Sprinklers and other fire safety measures in new high-rise blocks of flats

Response from the Chartered Institution of Building Services Engineers

28th November 2019

Exhibit 7.6

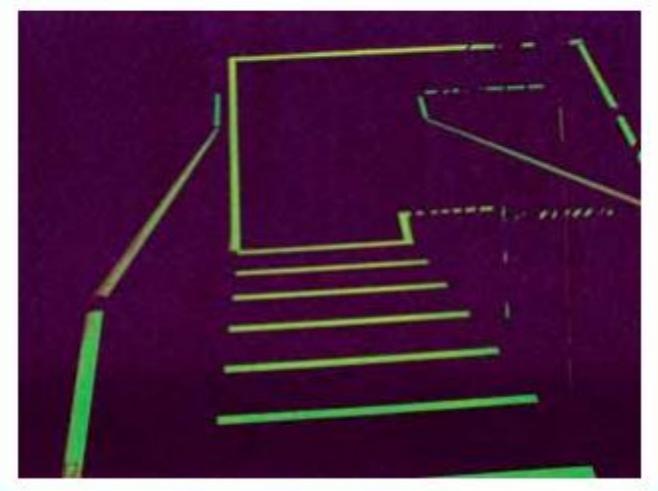
6b - What is the preferred option set out above for wayfinding signage? Vinyl lettering, photoluminescent lettering, emergency powered lighting luminaries, other (please specify). Providing emergency lighting is relatively easy. The EGRESS signage should be self-illuminated (battery pack) or emergency lighting should be provided that also lights a vinyl lettering sign. Photoluminescent signage is a good option. Vinyl lettering may not be readily visible in all conditions.

Some additional examples of signage have been provided by a senior practitioner below.

Figure A.7.2.2.5.4 Example of a Stairway Marking Sign.

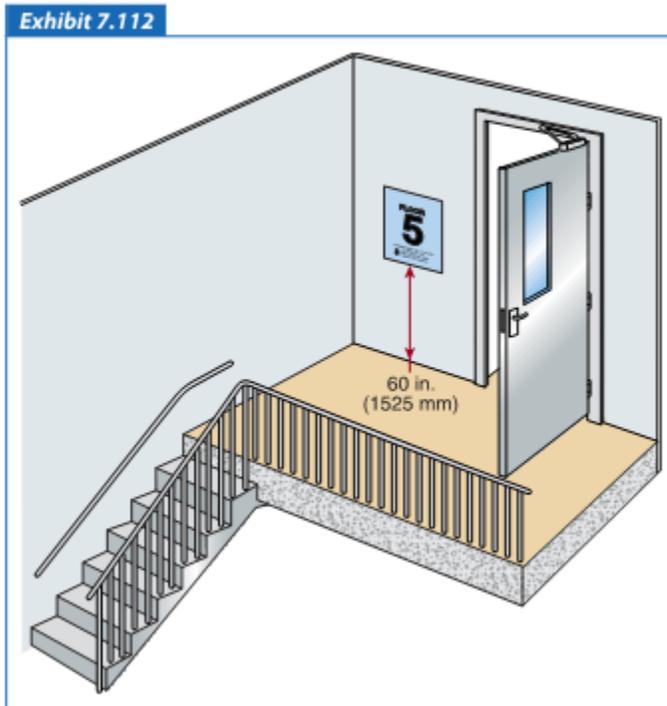
Example of stair signage below
